Project	A13394/VAA - Barnham Eastergate Westergate (BEW) Parcel SC1
Document Title or Subject	A13394 BEW - Whyke Road Roundabout Technical Note F01 2023-06-13
Document Reference	A13394/VAA-PEF-XX-XX-TN-TR-000051
Revision Reference	F01 – FINAL
Date	13 June 2023

2 Response to National Highways (NH) / SYSTRA Comments

Figure 1 -- Lane Markings on A27 (W) (Eastbound towards Junction)

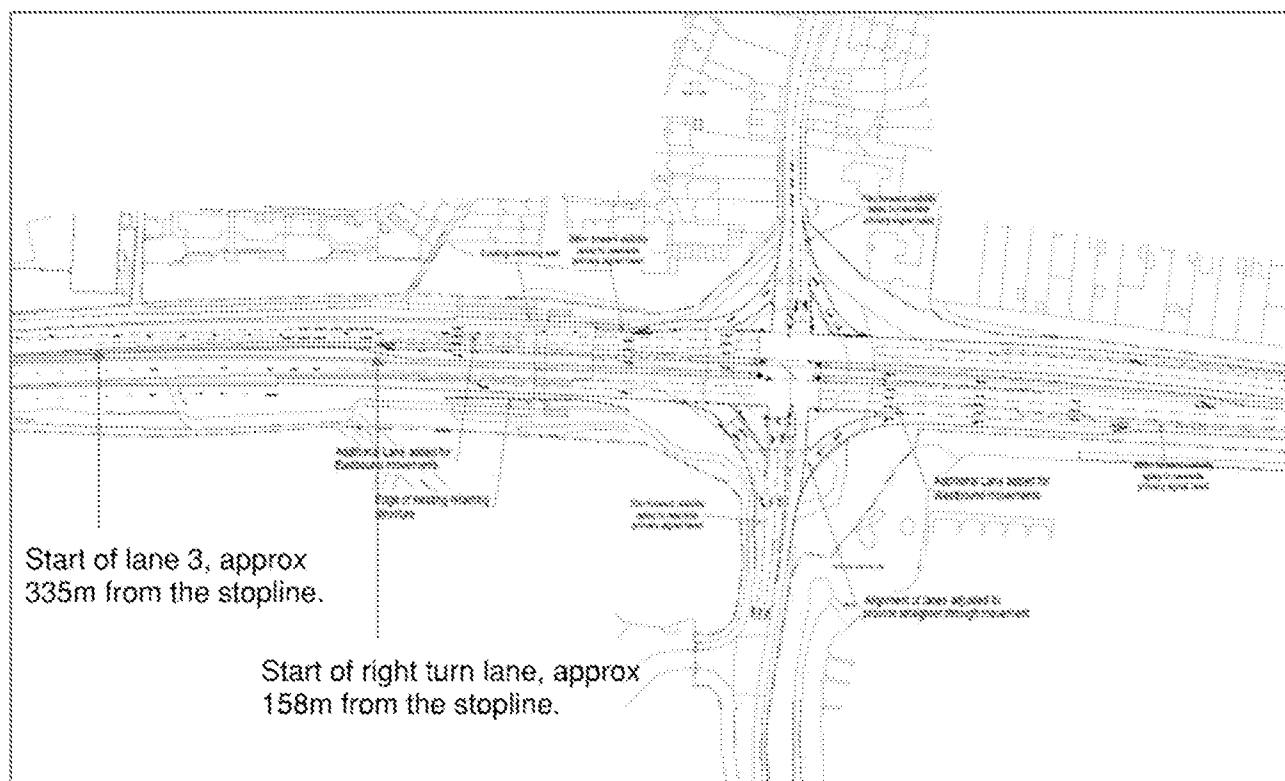
1. The safety implications of an extension of the queue are manageable – i.e. that adding 10 PCUs (the figure taken from the 2031 DM and DS model comparisons) to the DM queue does not block access points, or lead to issues with sighting of the rear of the queue that would increase the risk of vehicle collisions; or

If a drawing can be provided showing the change in the physical extent of the queue between the DM and DS 2031 models, I would be hopeful that we can agree option 1, in which case we should have what we need to be able to confirm the necessary conditions and provide our formal response accordingly.

- 2.1.2 In the 2031 Do Minimum (DM) model, the MMO is 49 PCUs (282m) increasing by 10 PCUs in the 2031 Do Something (DS) scenario to 59 PCUs (339m) on the A27 (W) arm. The queue would not block any access points or block the ahead movement at the junction due to two long lanes stretching back to the next junction approx. 1km away. **Figure 1** illustrates the start of the right turn lane and lane 3.
